Re: Rozelle Interchange Westconnex Application number SSI 7485

Our response to the modified EIS:

Below we have included a 'marked up' image where:

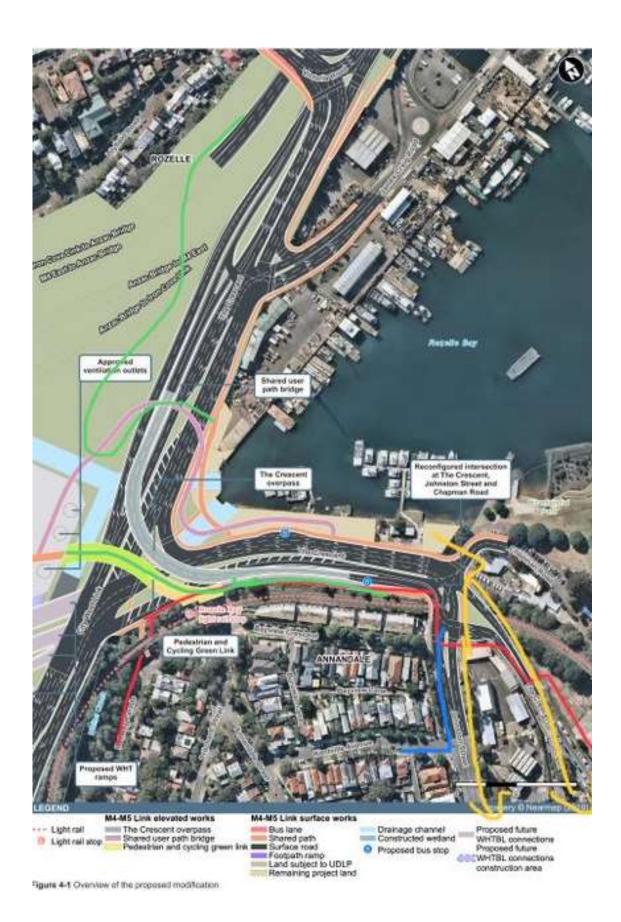
- Green is a more direct link from Anzac Bridge/Vic Rd,
- Yellow is Johnston St desire line
- Blue is a link to Kentville St.
- Red is the path along the mural side of The Crescent
- Green is the Green Link.

The purple pedestrian down ramp is obscured. The routes south from the light rail to Annandale, e.g. to Annandale St, that the Green Link would facilitate have been omitted.
